GULF STATES UTILITIES COMPANY

January 31, 1985
RBC- 20045
File Nos. G9.5,
G9.19.2

River Bend Station-Unit 1
Docket No. 50-458

Gulf States Utilities Company (GSU) provides the enclosed response addressing the River Bend Station (RBS) Safety Evaluation Report (SER) Confirmatory Item No. (5) - Effects of Annulus Pressurization. The attached information will be provided in a future amendment to FSAR Sections 3.9B for the Nuclear Steam Supply System scope and 3.9A for the Balance of Plant scope. This completes GSU's response to Question 210.92.

FIGURE 3.9A-13
 PIPE STRESS ANALYSIS MODEL
 RHS - LPCI SYSTEM
 AX-71B
 (INSIDE CONTAINMENT)
 RIVER BEND STATION
 FINAL SAFETY ANALYSIS REPORT

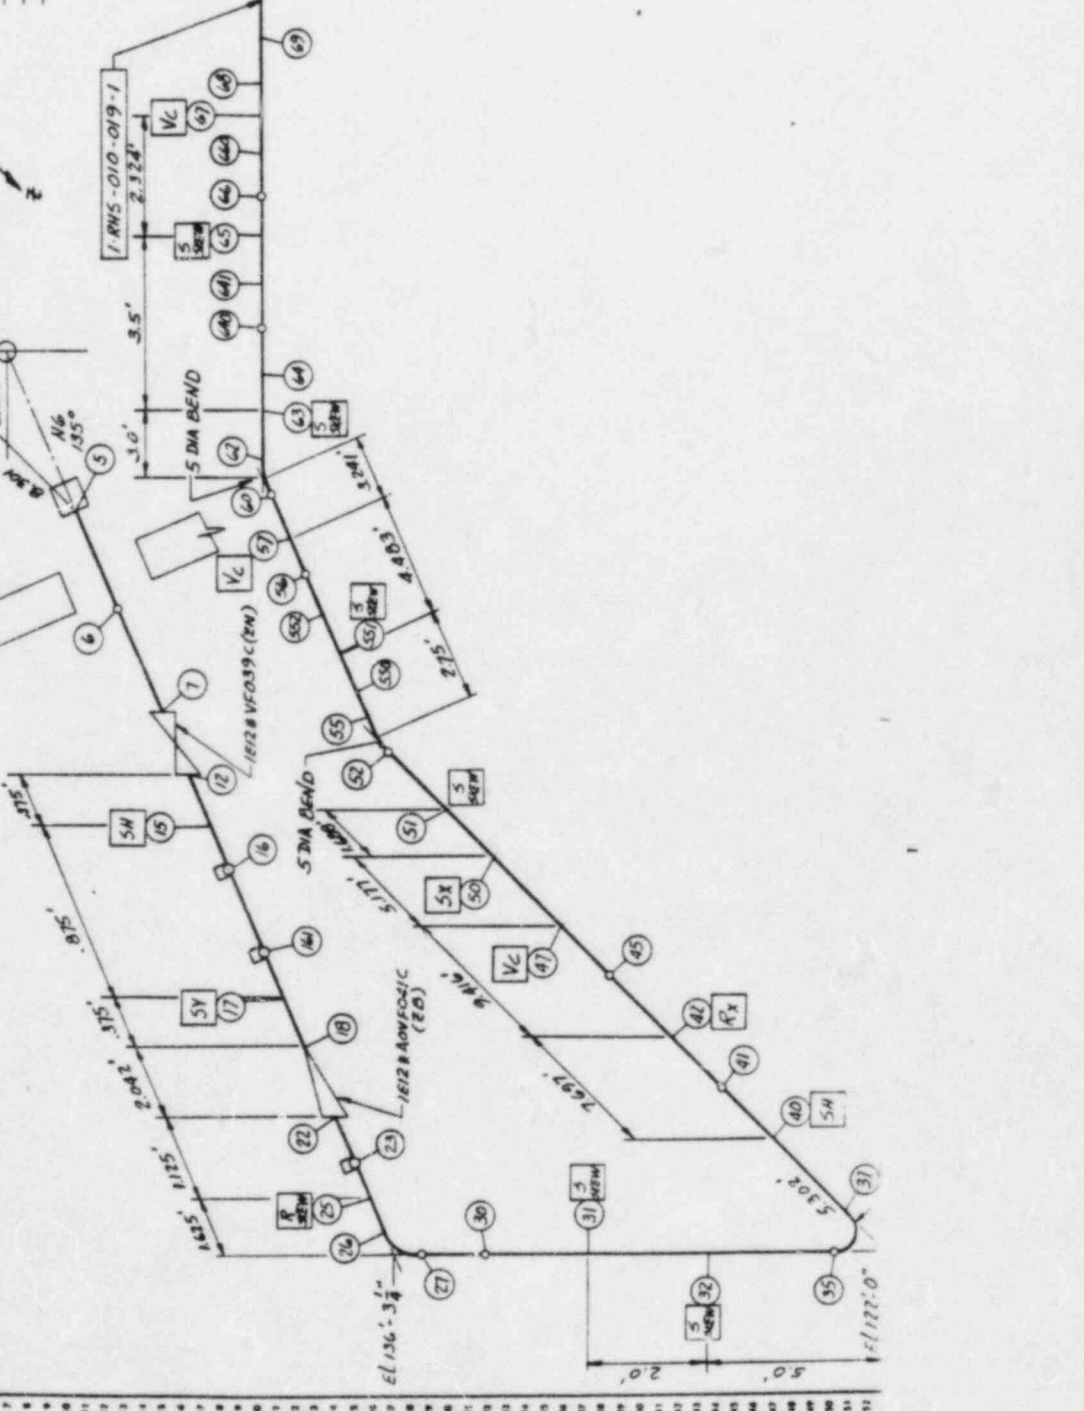
FSAR
TABLE 3.9A-16 (cont'd.)
RHS LPCI SYSTEM
STRESS PROBLEM AX-71B

NODE	PRIMARY STRESS (PSI)	ALLOWABLE (PSI) 3Sm
70	12392	60000
72	17889	60000
75	24558	60000
76	15214	60000
77	24174	60000
80	22034	60000
82	15399	60000
85	17376	60000

See Figure 3.9A-13

FIGURE 3.9A-14
 PIPE STRESS ANALYSIS MODEL
 RHS-LPCI SYSTEM
 AX-71C
 (INSIDE CONTAINMENT)
 RIVER BEND STATION
 FINAL SAFETY ANALYSIS REPORT

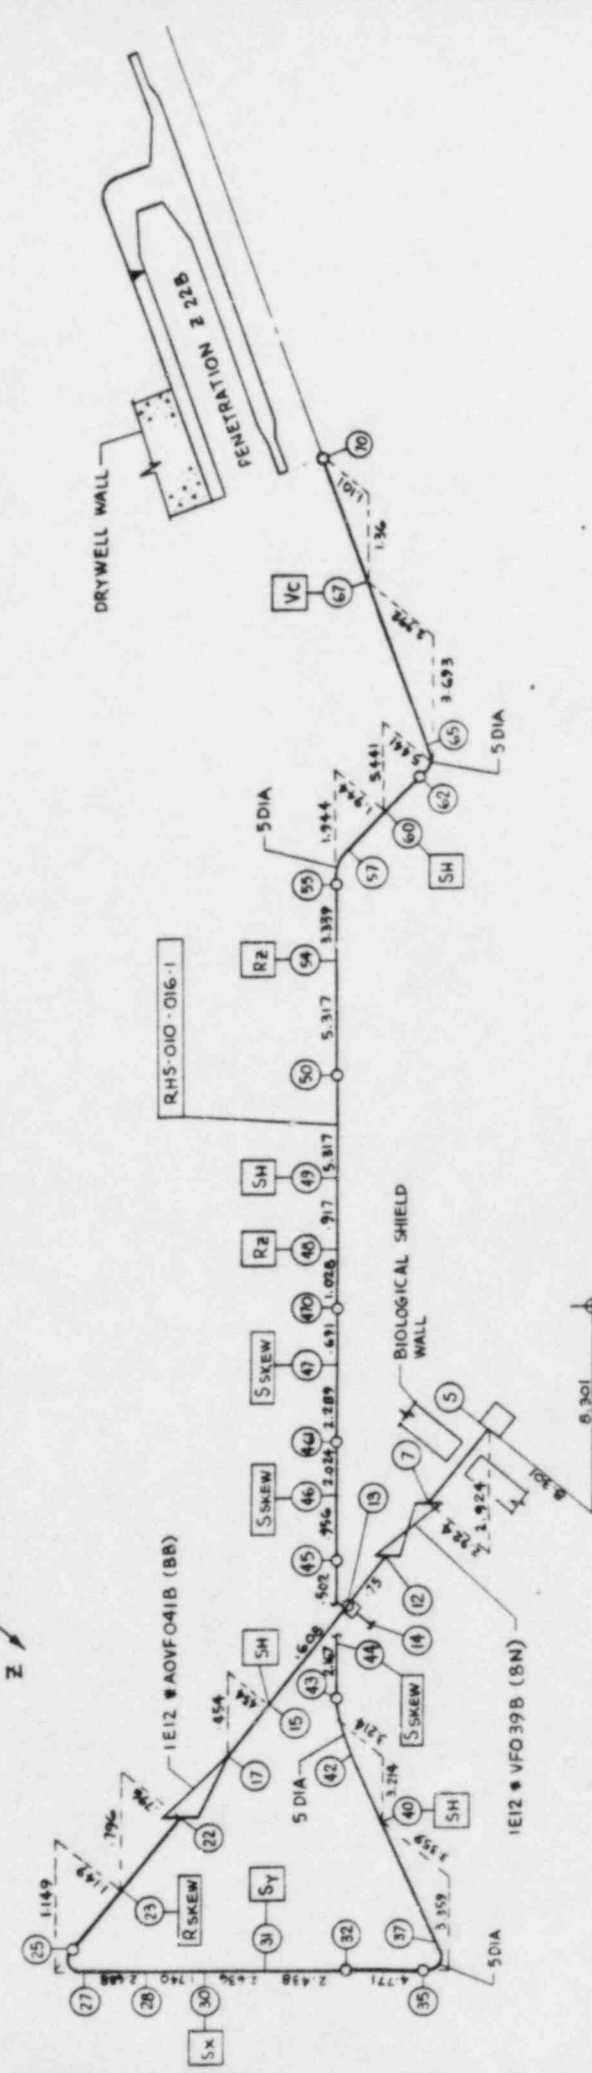
FSAR
 TABLE 3.9A-17
 RHS LPCI SYSTEM
 STRESS PROBLEM AX-71C

NODE	PRIMARY STRESS (PSI)	ALLOWABLE (PSI) 3Sm
5	30600	55356
6	20244	55356
7	14809	55356
12	16265	55356
13	29375	55356
14	2131	55356
15	18419	55356
17	18575	55356
22	14126	60000
300	21112	60000
23	11893	60000
25	21910	60000
27	22062	60000
28	13771	60000
30	14054	60000
31	14036	60000
32	13408	60000
35	27651	60000
37	27432	60000
40	12747	60000
42	21062	60000
43	26169	60000
45	13325	60000
46	14637	60000
461	12034	60000
463	11385	60000
47	11777	60000
470	11584	60000
48	11557	60000
49	11258	60000
50	13593	60000
54	13255	60000
55	27209	60000
57	24592	60000
60	12041	60000
62	27133	60000
65	25558	60000
67	11893	60000
70	11334	60000

See Figure 3.9A-14

FIGURE 3.9A-15

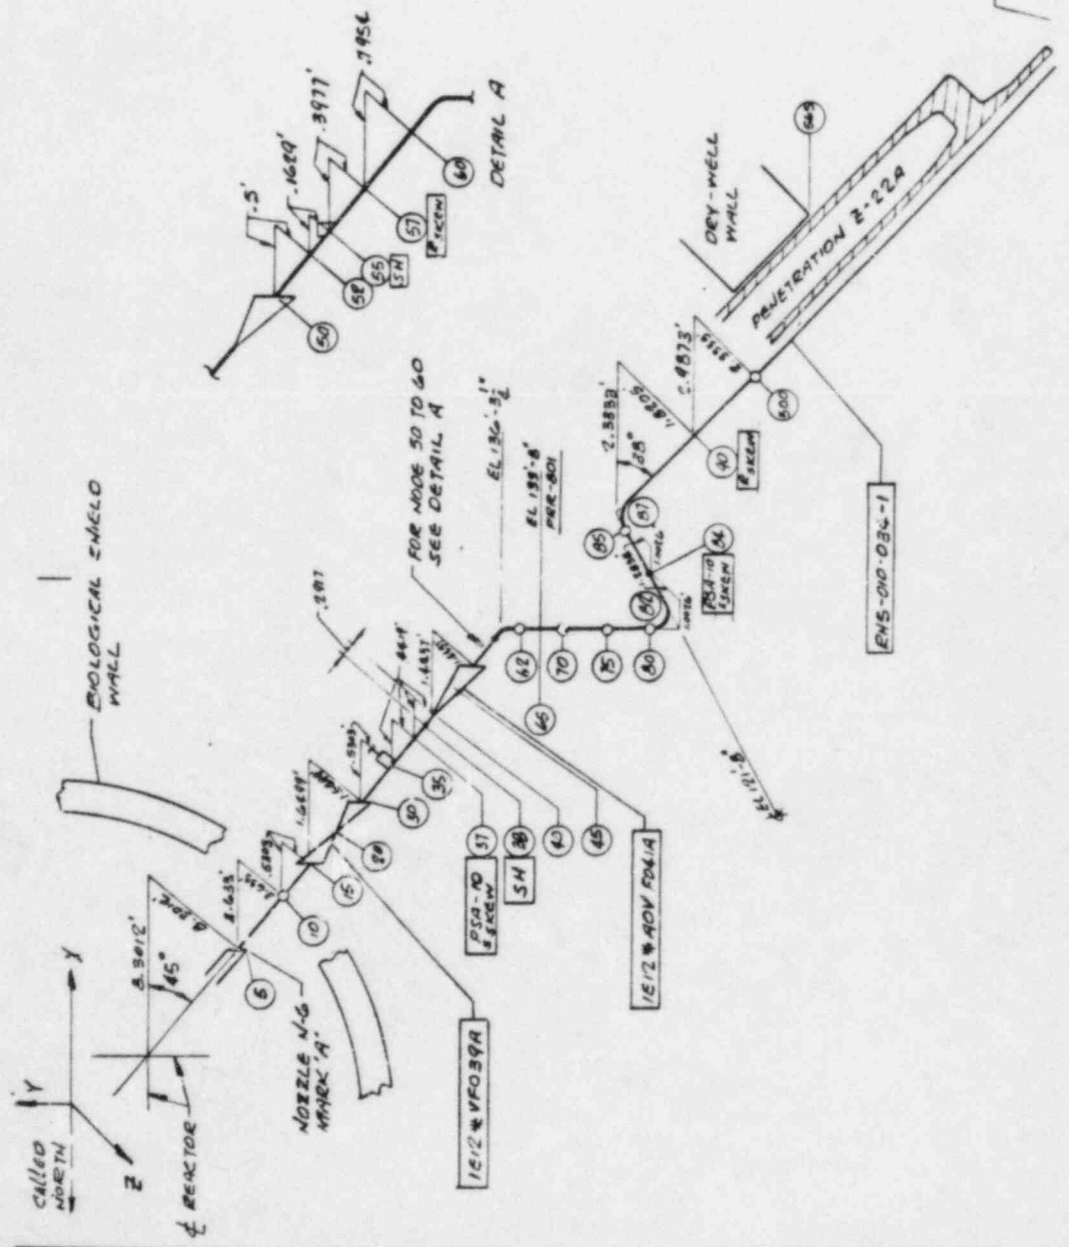
FSAR
 TABLE 3.9A-18
 RHS LPCI SYSTEM
 STRESS PROBLEM 3A-71D

NODE	PRIMARY STRESS (PSI)	ALLOWABLE (PSI) 3Sm
5	20169	55356
6	13069	55356
8	11285	55356
10	14682	55356
15	16333	55356
30	17124	55356
35	37478	55356
37	16525	55356
38	16385	55356
40	16414	55356
50	13591	60000
52	25640	60000
55	12582	60000
57	11872	60000
60	27826	60000
62	22535	60000
65	10282	60000
70	13709	60000
75	11004	60000
80	23657	60000
82	18489	60000
84	6529	60000
85	19764	60000
87	24898	60000
90	13374	60000
500	13347	60000

See Figure 3.9A-15

FIGURE 3.9A-16
 PIPE STRESS ANALYSIS MODEL
 C SL SYSTEM
 AX-78A
 (INSIDE CONTAINMENT)
 RIVER BEND STATION
 FINAL SAFETY ANALYSIS REPORT

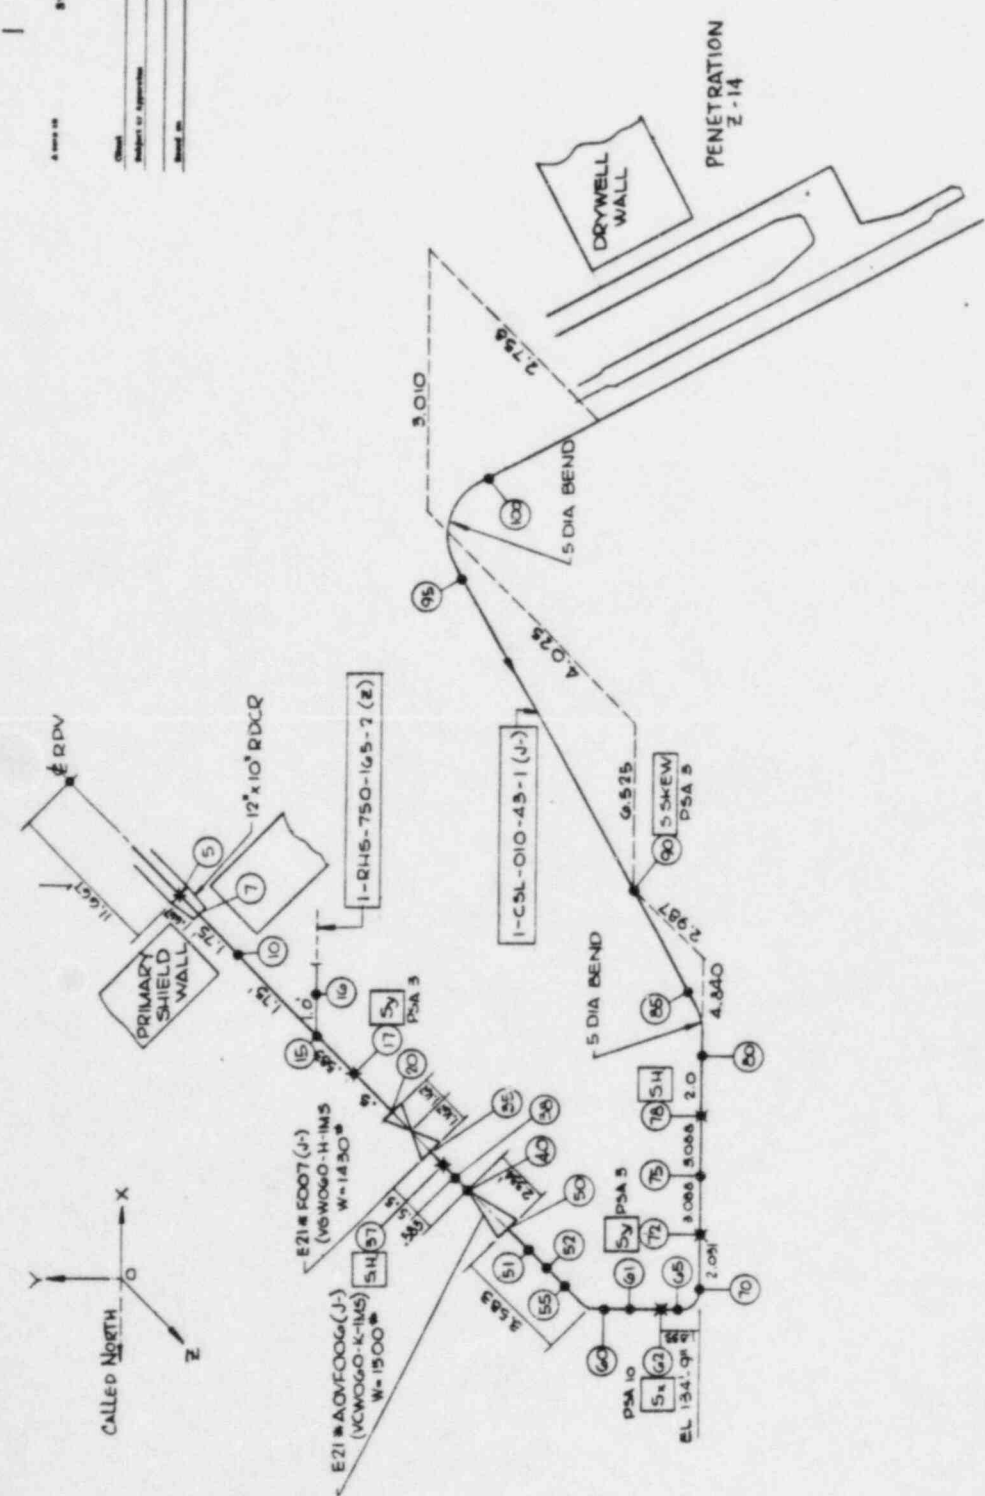
FSAR
 TABLE 3.9A-19
 CSL SYSTEM
 STRESS PROBLEM AX-78A

NODE	PRIMARY STRESS (PSI)	ALLOWABLE (PSI) 3Sm
5	13667	55356
7	21984	55356
10	16890	55356
15	13640	55356
17	13325	55356
20	13565	55356
35	15733	55356
37	16532	55356
38	16583	55356
40	16634	55356
50	15604	60000
51	15337	60000
52	15025	60000
55	21022	60000
60	18930	60000
62	12902	60000
65	19509	60000
70	18515	60000
72	13334	60000
75	13181	60000
78	14348	60000
80	30497	60000
85	28464	60000
90	10864	60000
92	10992	60000
95	23056	60000
100	22388	60000

See Figure 3.9A-16

FIGURE 3.9A-17
 PIPE STRESS ANALYSIS MODEL
 CSH SYSTEM
 AX-B3A
 (INSIDE CONTAINMENT)
 RIVER BEND STATION
 FINAL SAFETY ANALYSIS REPORT

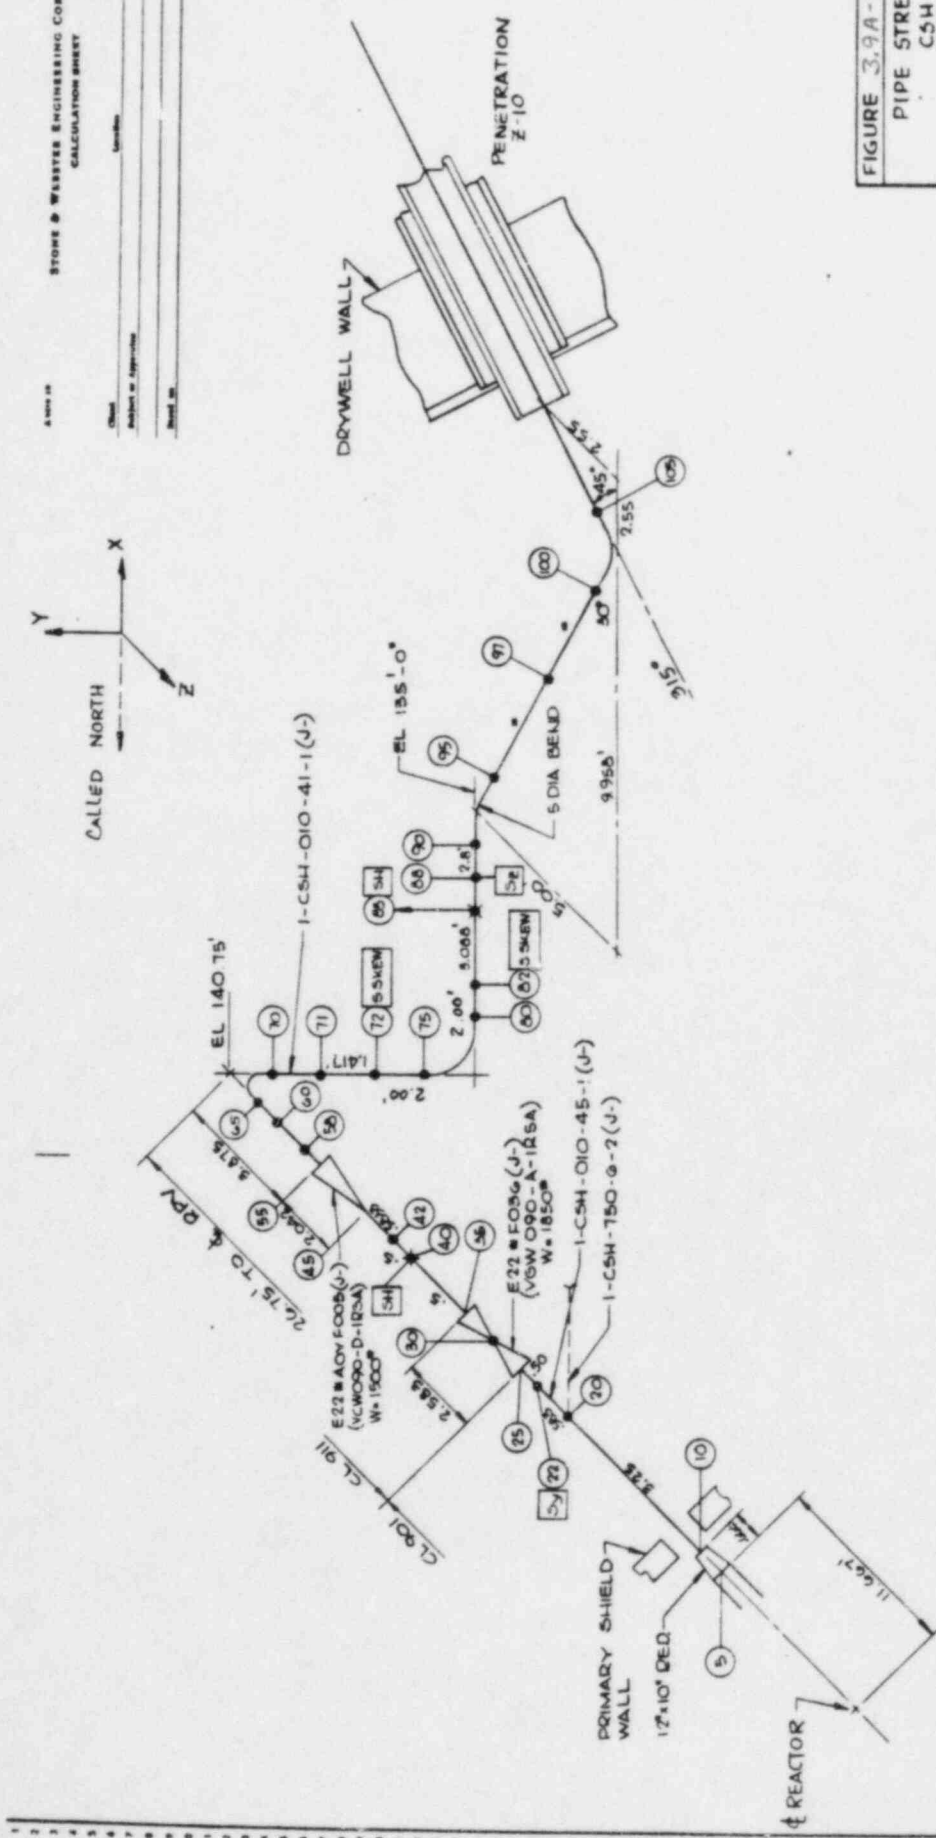
FSAR
TABLE 3.9A-20
CSH SYSTEM
STRESS PROBLEM AX-83A

NODE	PRIMARY STRESS (PSI)	ALLOWABLE (PSI) 3Sm
5	15124	55356
10	22447	55356
2011	14502	55356
20	28992	55356
22	2685	55356
25	15407	55356
35	16565	55356
40	16839	55356
42	16705	55356
45	16462	55356
55	14992	60000
58	14168	60000
60	11566	60000
65	19795	60000
70	19348	60000
71	11313	60000
72	12548	60000
75	20177	60000
80	21032	60000
82	12081	60000
85	13703	60000
88	13543	60000
90	24090	60000
95	26575	60000
97	13191	60000
100	13953	60000
105	15183	60000

See Figure 3.9A-17
